DEVIATION REQUEST AND DECISION FORM

Project Name :	Yucatan Convenience Store
Schedule No.(s) :	6501205016
Legal Description :	Lot 1 Clearview West Filing No. 2 (4815 Yucatan Dr. Colorado Springs, CO 80911)

A deviation from the standards of or in Section **2.3.7.D.2** of the Engineering Criteria Manual (ECM) is requested.

Figure 2 - 6. Guideline for determining the need for a major-road right-turn bay at a two-way stop-controlled intersection.

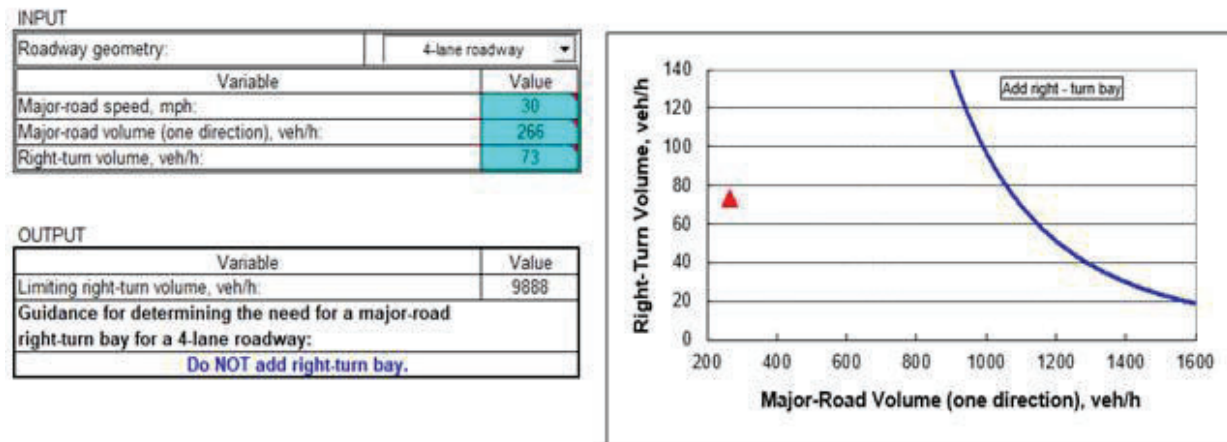
As you can see in Figure 2-6 below, the data point representing this site and its traffic/access volumes does not remotely approach meeting the threshold for suggested implementation of a right turn lane. A right turn volume of 73 veh/hr would require over 1000 veh/hr of through-traffic to be considered disruptive enough to warrant a right-turn lane (Compared against the Major-Road Volume of 266 veh/hr, a volume almost a quarter of that. This indicates that utilizing a through lane for right-turns onto the site will not be disruptive to through-traffic, nor to the functionality of the roadway or the Hancock/Yucatan intersection.

Because the through-traffic volume required (based on NCHRP 279 guidelines) to warrant a separate right-turn lane at the right-turn volume for this site (73 veh/hr) is nearly 4 times the actual through-traffic volume (>1000 veh/hr vs. 266 veh/hr), the factor of safety and level of operational functionality will not be negatively impacted by utilizing a through lane for right-hand turns onto the site.

This request has been determined to have met the criteria for approval. A deviation from Section 2.3.7.D.2 of the ECM is hereby granted based on the justification provided.

Implementation of modifications to the access may be required at the owner's expense if safety or capacity issues arise. This may include, but is not limited to, relocation or closure of the access drive if additional access becomes available, or installation of a dedicated right turn lane.
